NUMBER: 09-010-06

GROUP: Engine

THIS BULLETIN SUPERSEDES TECHNICAL SERVICE BULLETIN 09-005-05, DATED DECEMBER 2, 2005, WHICH SHOULD BE REMOVED FROM YOUR FILES. THIS IS A COMPLETE REVISION AND NO ASTERISKS HAVE BEEN USED TO HIGHLIGHT REVISIONS.

Multiple Cylinder Misfire Or Rough Idle

Fig. 2 LX MODELS - MAP SENSOR

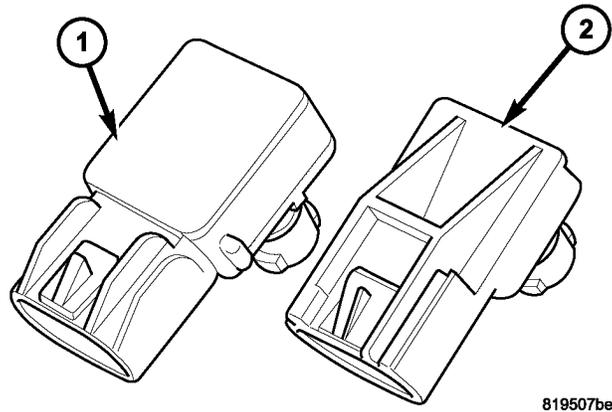
1. Inspect the MAP sensor ([Fig. 2](#)) for LX models or ([Fig. 3](#)) for CS models.
 - a. If the MAP sensor is the new style, no further action is necessary for the MAP sensor. Proceed to Decarboning Combustion Chamber and Valves.
 - b. If the MAP sensor is the old style, proceed to the next step.

2. Replace the MAP sensor with p/n 05033310AC for LX models or p/n 04896003AB for CS models. If the vehicle is a CS model, be sure the new sensor opening is facing a downward direction when installed and only use one fastener. Refer to the detailed service information available in TechCONNECT, under: Service Info > 14-Fuel System > Fuel Injection > MAP Sensor > Removal and Installation. When complete, proceed to Decarboning Combustion Chamber and Valves.
